Reference: TVA letter to NRC dated January 15, 2002,
"Sequoyah Nuclear Plant (SQN) - Steam Generator
Replacement Project - Topical Report No. 24370-
TR-C-002, "Rigging and Heavy Load Handling
Topical Report," Response to NRC Request for
Additional Information

ENCLOSURE 1
TENNESSEE VALLEY AUTHORITY
SEQUOYAH NUCLEAR PLANT (SQN)
UNIT 1

DOCKET NO. 327
ADDITIONAL INFORMATION FOR NRC QUESTION 14
TOPICAL REPORT NO. 24370-TR-C-002,
RIGGING AND HEAVY LOAD HANDLING"

ENCLOSURE 2
TENNESSEE VALLEY AUTHORITY
SEQUOYAH NUCLEAR PLANT (SQN)
UNIT 1
DOCKET NO. 327
COMPARISON OF CRANES

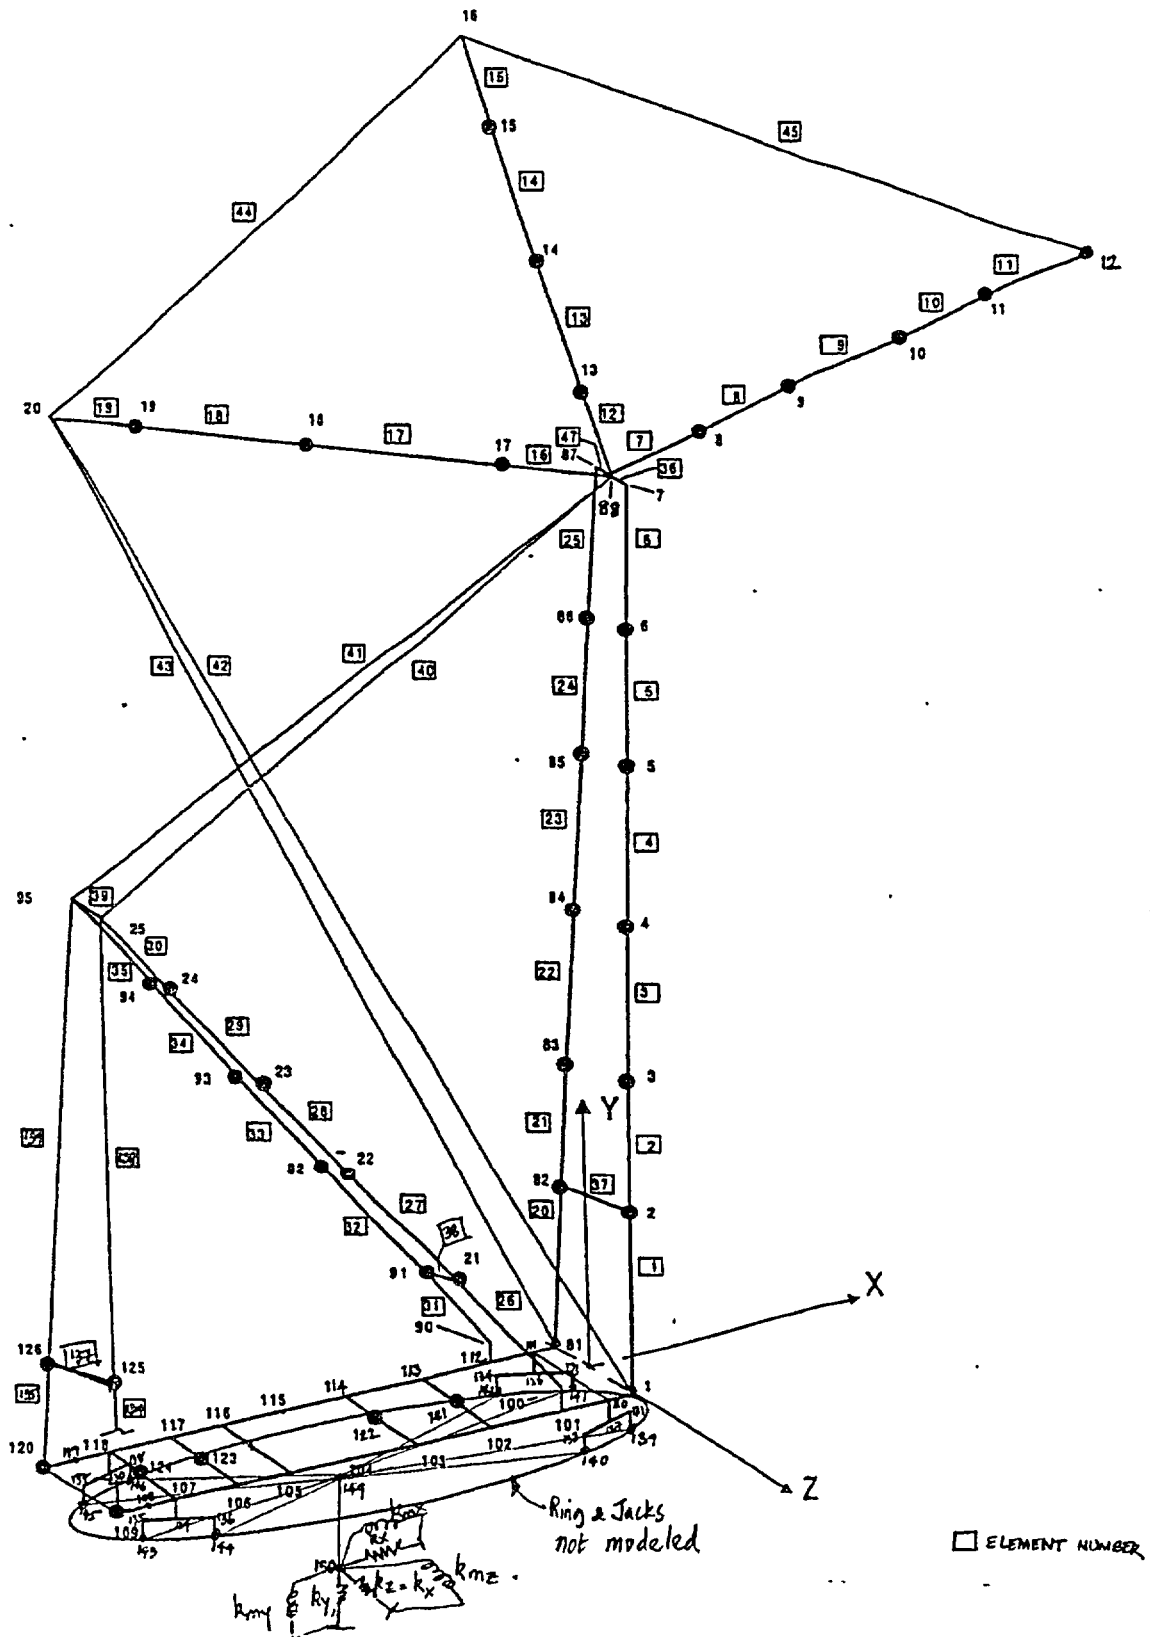
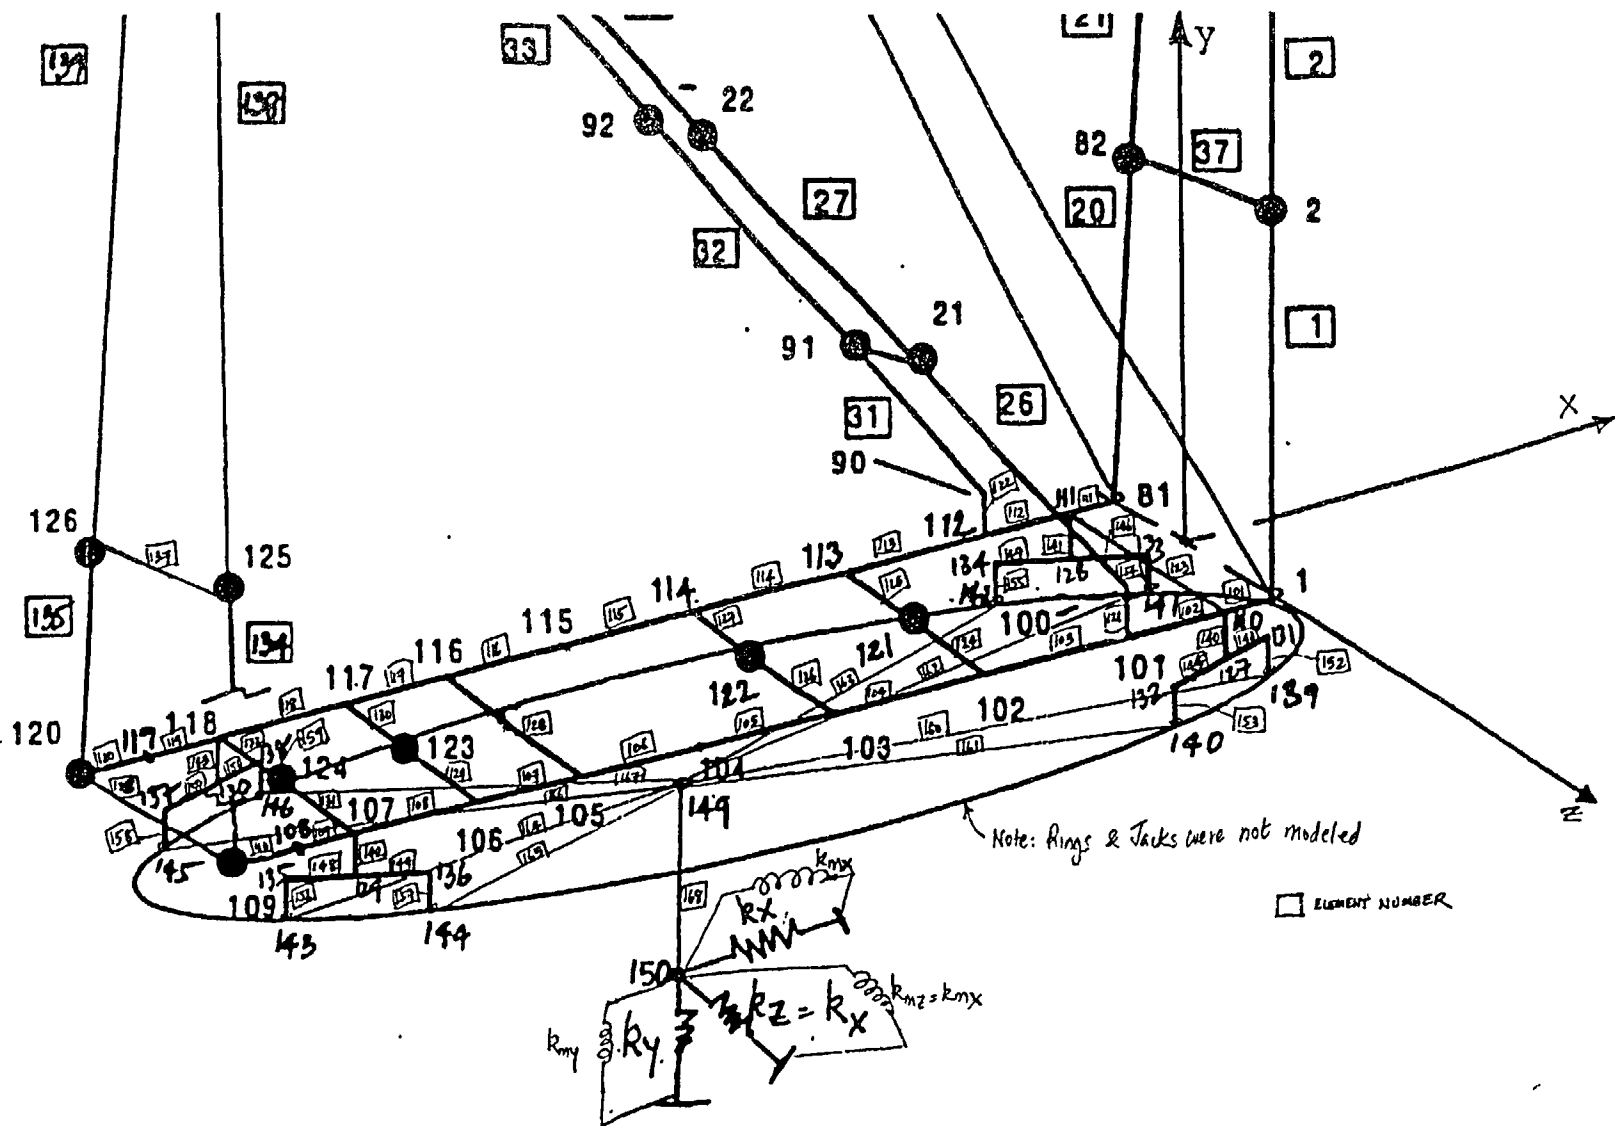
14. Provide a description of how the OLS is anchored to the platform and describe the critical locations in the load carrying parts of the OLS for the various boom configurations. During a design basis earthquake with or without the largest postulated lifted load to include pendulum and swinging loads, demonstrate that the OLS will remain anchored to the platform and that the platform and OLS will be prevented from overturning.

Schematic sketches of the finite element model showing the members, joints and boundary conditions (at the base) are provided as Figures 1 and 2.

The base ring and jack stands were not explicitly modeled. The wheel-system on the base ring of the crane is represented by vertical members with pinned ends at the 8 joints (Joints 139 to 146 - see Figures 1 and 2) in the model where the wheel-system is in contact with the base ring. Note that the wheel system is provided with up-stop devices to the under side of the base ring flange plates on which the wheels ride, thereby providing restraint against uplift from the ringer base. The base-ring and outrigger ringer/plate system of the crane is a rigid system. Therefore, the base-ring and outrigger ringer/plate system is represented in the model by rigid horizontal links from the 8 wheel joints to the center of the crane at the level of the base ring and thereon by a rigid vertical link to the foundation (pile cap) (Joint 150 - see Figures 1 and 2).

Soil-structure interaction effects at the foundation have been incorporated by including 6 soil springs at the foundation joint (Joint 150). The spring constants represent the horizontal (k_x & k_z), vertical (k_y), rocking (k_{mx} & k_{mz}) and torsional (k_{my}) stiffnesses of the soil-pile foundation system. These spring constants were computed using published formulas in soil dynamics literature for circular bases (Reference: p169, Table 7.1 of Wu, T.H., *Soil Dynamics*, Allyn

Figure 2 – PRHD Crane

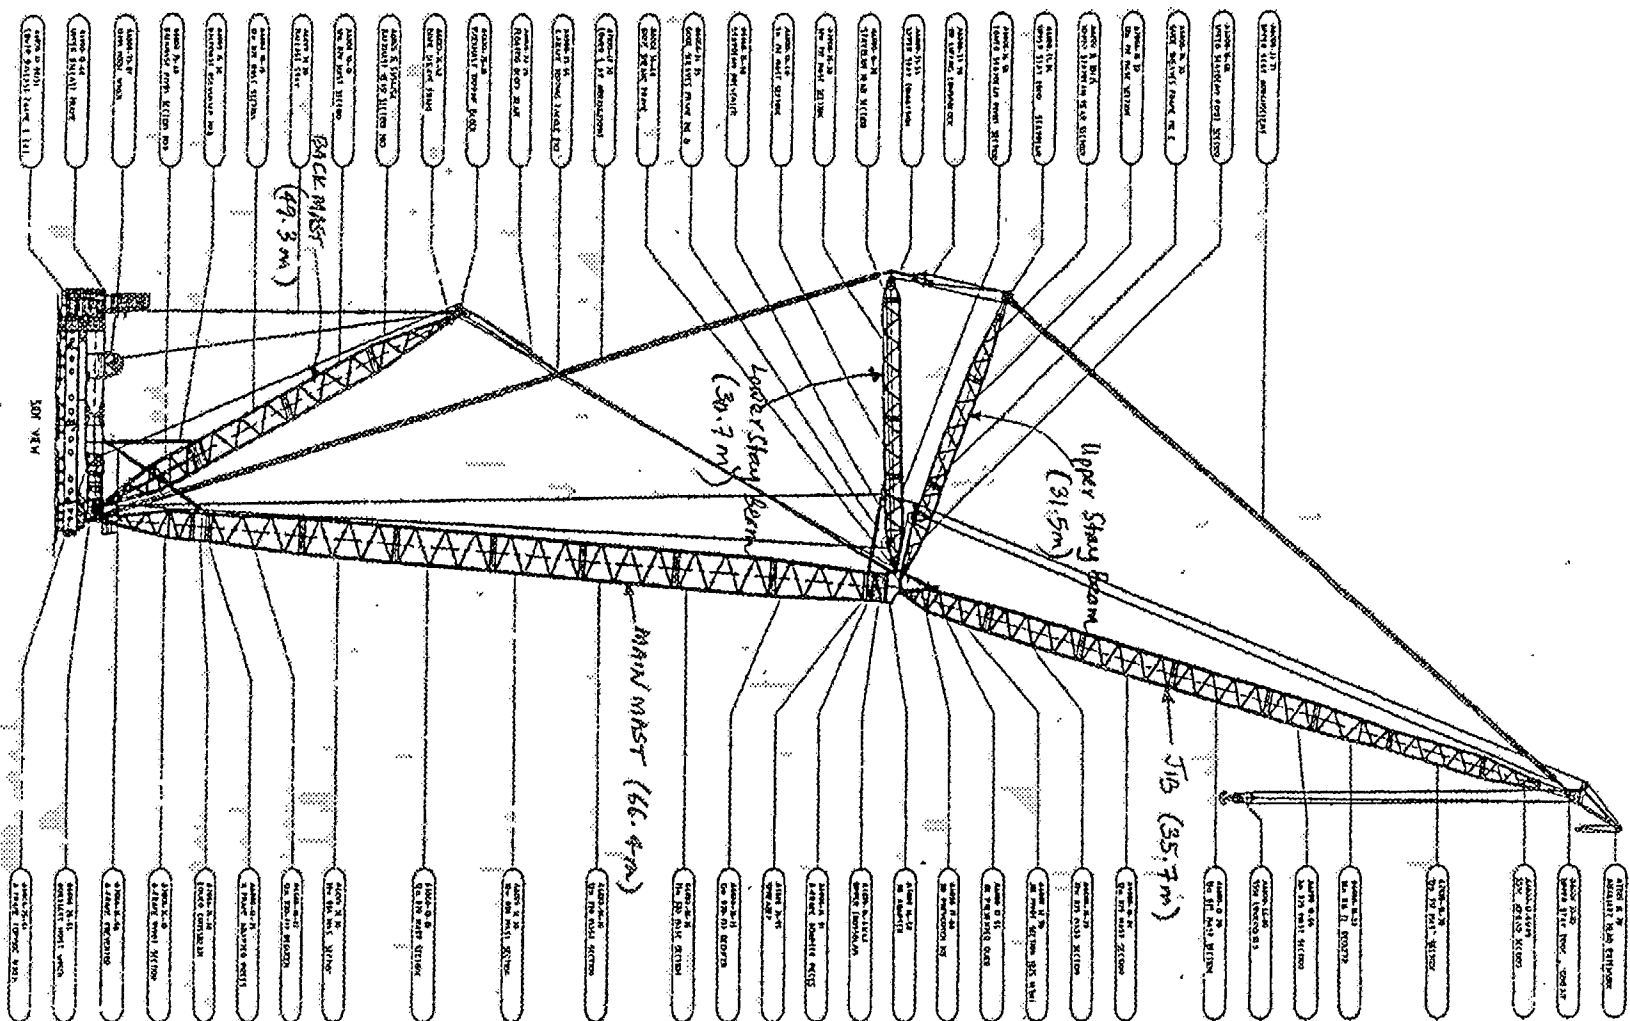
To evaluate and document the acceptability of the PRHD crane, a comparison of PTC crane attributes (detailed in Topical Report 24370-TR-C-002 and RAI responses) to the corresponding PRHD crane attributes is provided in the following table. Elevation views of the PTC and PRHD cranes are also provided as Figures 1 and 2, respectively. Two comparison bases are used to demonstrate similarity of the cranes: (1) direct comparison of the physical attributes; and (2) evaluation of the PRHD dynamic response characteristics under SSE for one of the critical configurations. Based on the comparison of the two cranes, it is shown that the conclusions of Topical Report 24370-TR-C-002 remain unchanged in that the attributes of the PRHD crane meet or exceed those of the PTC crane.

The PRHD and PTC cranes are very comparable in design, construction, lift capacity (better for the PRHD), operation and dynamic response under seismic loads. The PRHD crane base ring will be supported on 48 jacks as against 24 jacks for the PTC, providing an improved distribution of bearing pressures at the base. The seismic evaluation of the PRHD Crane established that the dynamic response characteristics of the PRHD crane are similar and further an improvement over that for the PTC crane. The margins of safety available for the structural components of the PTC crane were large enough that due to similarity in responses of the PTC and PRHD cranes, the stress levels in these elements will remain below yield stress for the PRHD crane. The evaluation determined that the factor of safety against overturning (critical failure mode) for the PRHD crane for the most critical configuration improved over that for the PTC crane. This is as expected since the two cranes have approximately the same mass (majority of which is located near the base), very similar dynamic response characteristics and the center of gravity of the PRHD is lower than that of the PTC. Therefore, the results and conclusions of the evaluation for the PTC crane remain valid for the PRHD crane. Thus, PRHD crane may be used as an alternate crane in lieu of the PTC crane for the Sequoyah Unit 1 SGRP.

Figure 3 – PRHD Boom Assembly Location

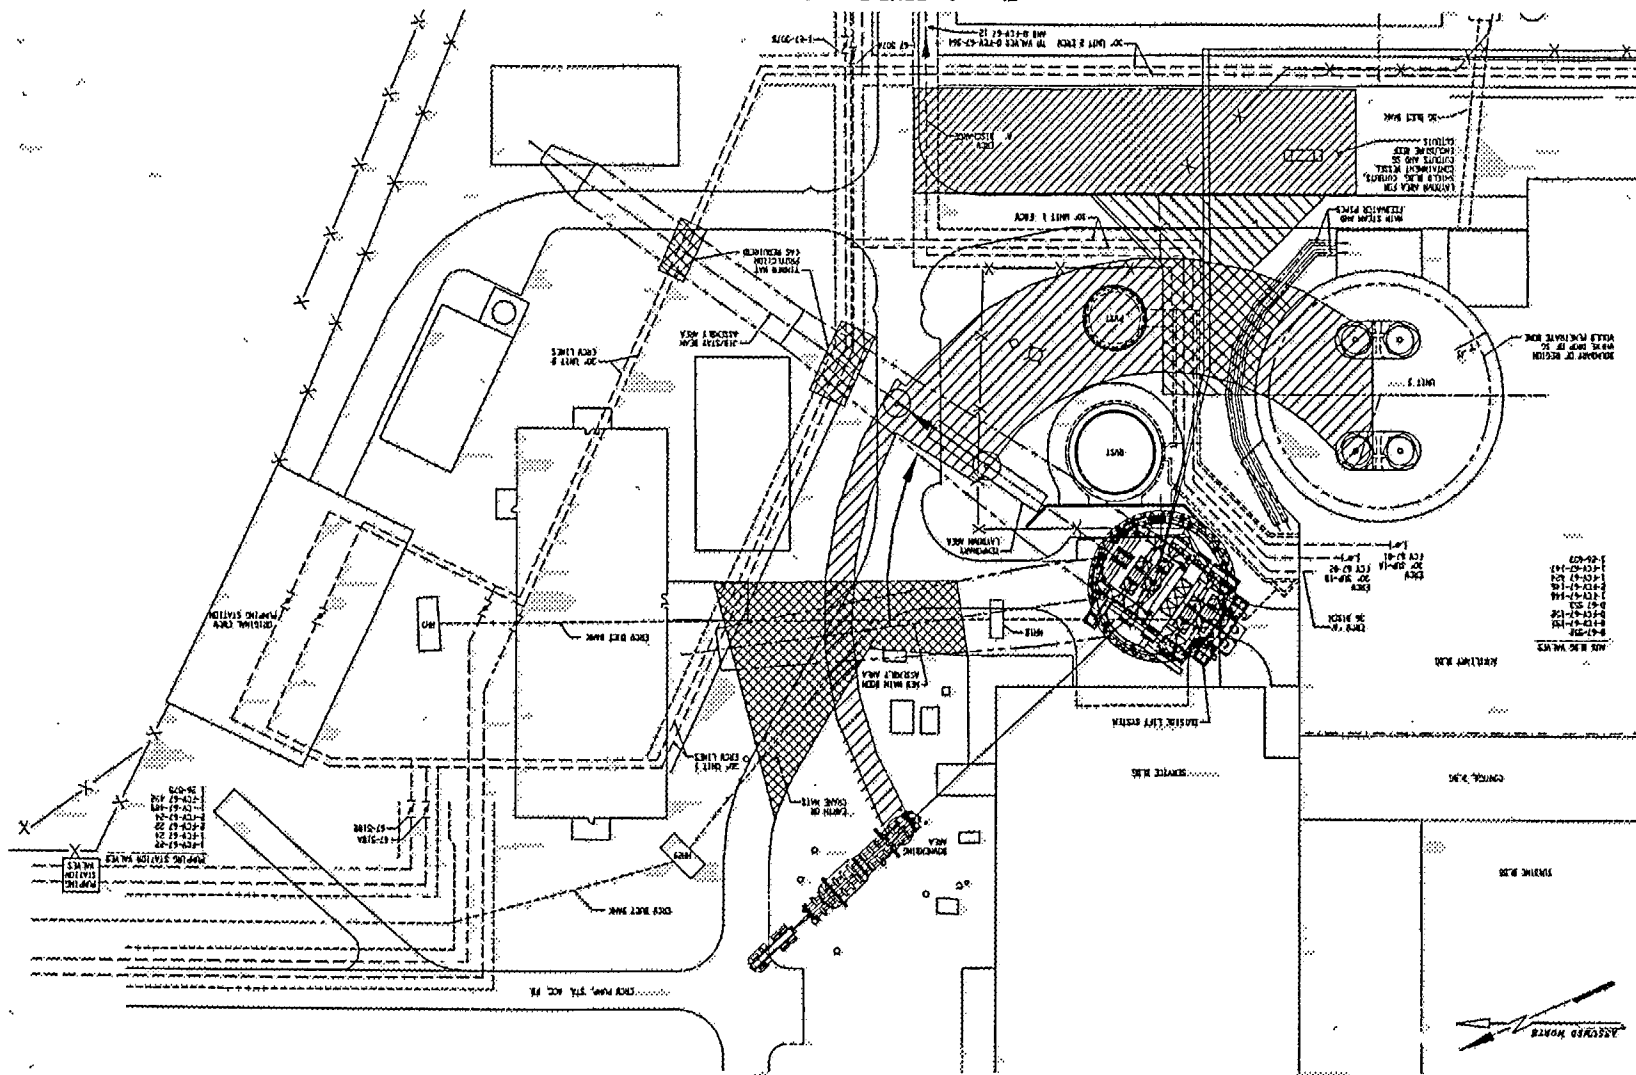
Crane Attribute	Description	PTC Crane	PRHD Crane	Remarks/Basis for Acceptability of PRHD Crane
	<p>TR Sects. 4.2, 5.1)</p> <ul style="list-style-type: none"> Main boom assembly (TR Sect. 5.1) 	<p>Assembly of the main boom will be performed in an area to the north of the Unit 1 Containment as shown on Figure 5-2 of Topical Report 24370-TR-C-002.</p>	<p>Assembly of main boom will start to the west of the position shown on Figure 5-2 of Topical Report 24370-TR-C-002 (as shown on Figure 3), which places the boom in a northerly direction from the crane base. This will allow assembly of the main boom on the ground without interfering with the RWST structure. The main boom will be attached to the base of the crane and moved to the position shown on Figure 5-2 of Topical Report 24370-TR-C-002 for erection of the jib and stay beams.</p>	<p>Assembly process is the same. If initial assembly occurred as shown in the topical report, it would have to occur off the ground to clear an interference with the RWST retaining wall. Controls for erection cranes and protection of underground equipment are the same. Therefore, no impact.</p>
